TCG121WX Series Package Change Notification

Please accept this letter as an official notification of the packaging change of TCG121WX series due to paper gasket reduction. Only TCG121WX series will be affected by this notification.

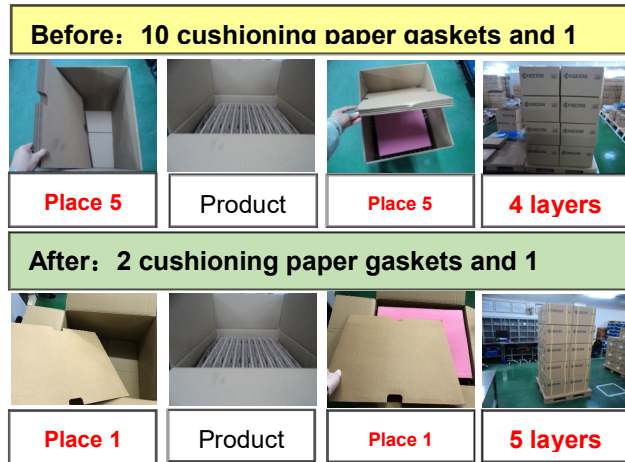
1) Total weight

Before change: 11KG

After change: 10KG

2) Packaging material

The number of paper gaskets change from 10 pieces to 2 pieces per box.

The height of each box is changed from 331mm to 290mm, other dimensions remain unchanged.

The quantity in each box remains unchanged.
